G.O. No.	2133 W	Press Mis.
105-6		
Dated	7-9	18 72

No. 105. From the Acting Superintending Engineer, 1st Division, to the Secretary to Government, Public Works Department, dated Dowlaishweram, 6th July 1872, No. 1,325.

Note by the Acting Chief Engineer for Irrigation.

PROPOSED DESIGN OF A SLUICE
BY SUPERINTENDING ENGINEER
OVER THE THOREGEDDA DRAIN

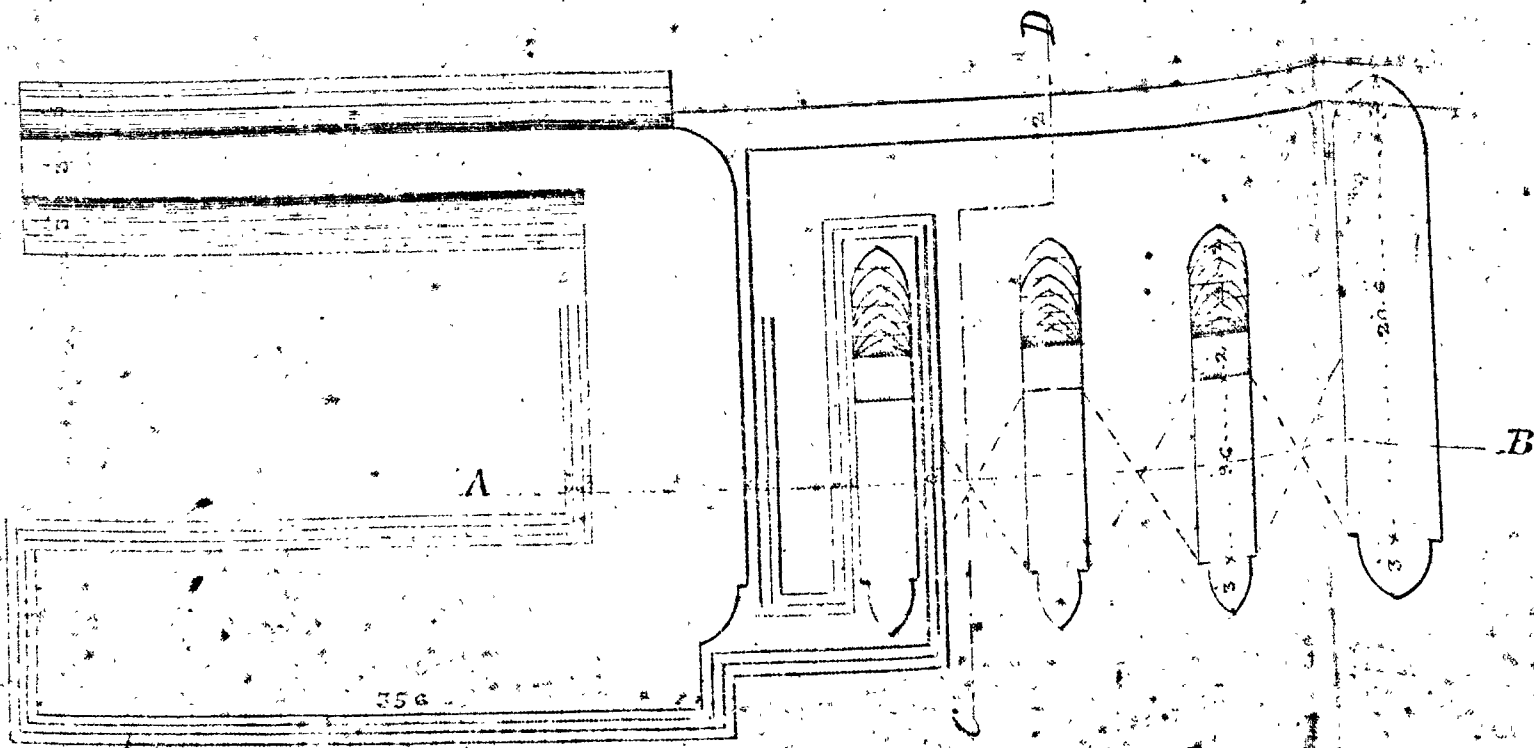
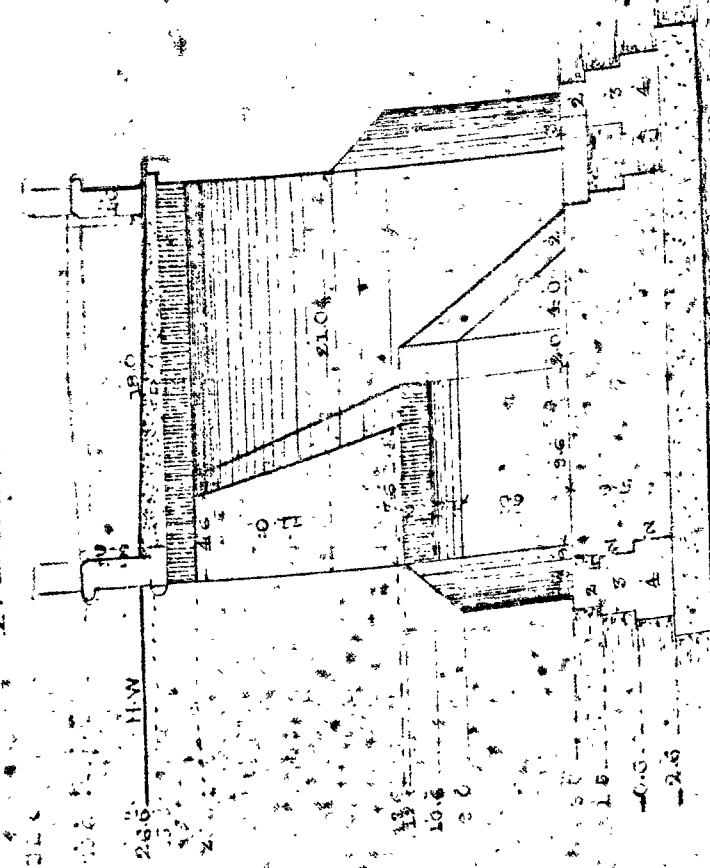
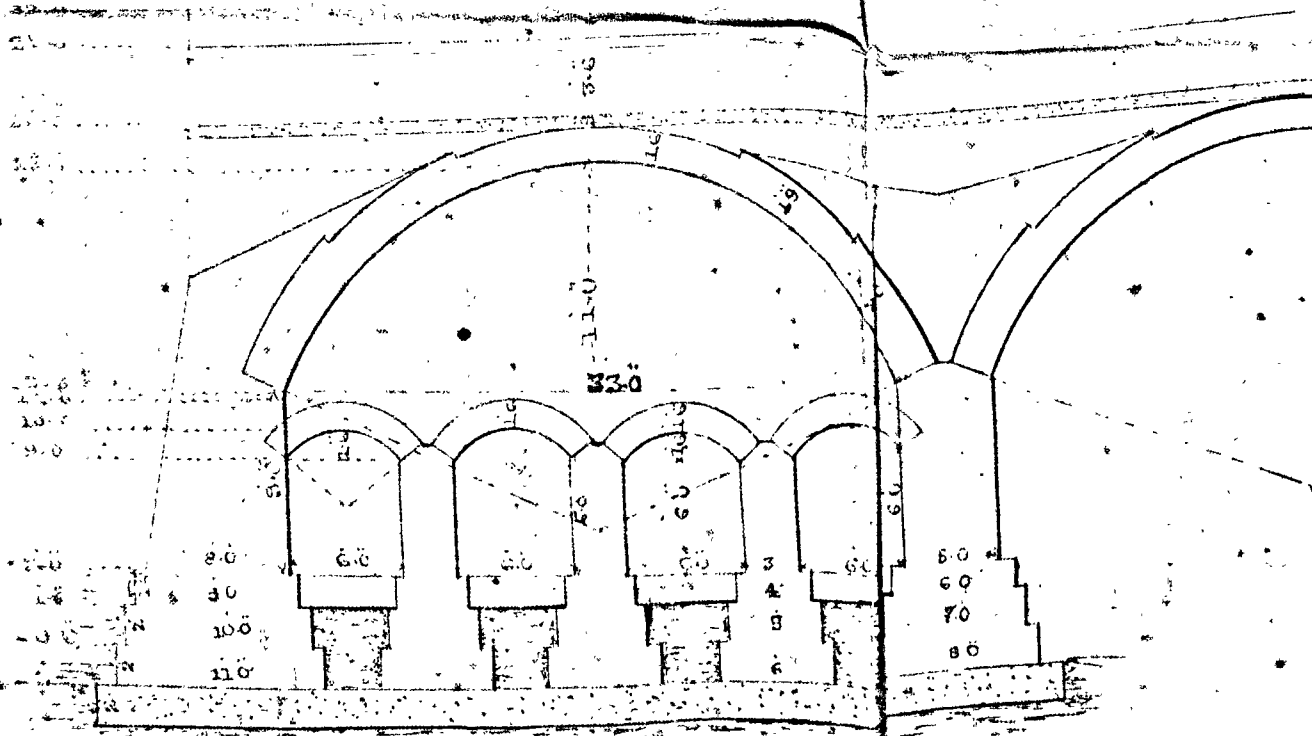
2. As it occurred to me that a work could be designed without such a width of arch as that proposed by the Acting Chief Engineer, and also without exposing so much of the embankment and roadway to the action of the river floods and waves, I beg to submit a plan and estimate, amounting to Rupees 14,750, for carrying the roadway in the ordinary manner over a bridge; in this estimate I have included the cost of concrete foundations such as we usually put down.

3. I have to explain, with reference to paragraph 2 of the Note of the Acting Chief Engineer, that, in the original design, the piers were constructed above the sluice arches, and filled in between with gravel, their thickness of 2 feet was, therefore, of no importance; the planking will be altered to 4 inches as proposed in paragraph 4. Whilst heavy floods prevail in the Godavery river, there is very little or no drainage running into it from this district; as far as our experience goes, generally speaking, the heavier the flood in the river the clearer is the weather here. I think, therefore, the design will answer for all purposes—my only doubt is, if an arch so flat as $\frac{1}{4}$ the span, and 50 feet wide, and only 18 inches thick throughout can be so well built in this country as it ought to be, particularly as the extrados will be liable to have at times a considerable quantity of wet earth on it.

With reference to your letter No. 125, dated 19th July 1872, I have the honour to forward herewith a revised estimate amounting to Rupees 13,200 and the plan of the sluice over the Thovigedda drain, with the alterations as suggested in your letter under reference duly carried out; but I beg to observe the original design provided for the discharge of only $\frac{1}{4}$ inch in twenty-four hours from the whole drainage area, and not for $\frac{1}{4}$ inch in one hour and 6 inches in twenty-four hours; I am, therefore, of opinion that the design should not be reduced.

IN G. O. No. 1,286, dated 14th May 1872, the Superintending Engineer of the 1st Division was directed to submit certain information relative to the Thovigedda drain to admit of its being determined whether it would be more economical to embank the stream and to provide a bridge where the river embankment meets the stream, or to provide a head-sludge by which the flood waters in the river might be excluded from the drain. From the information supplied by the Superintending Engineer, it would appear that the latter arrangement would be the more economical, and an estimate of Rupees 12,000 for the sluice is submitted for the sanction of Government. The sluice provides amply for the discharge of rainfall over the area of 375 square miles drained by the Thovigedda.

His Excellency the Governor in Council sanctions the revised estimate of Rupees 12,000 for a sluice at the
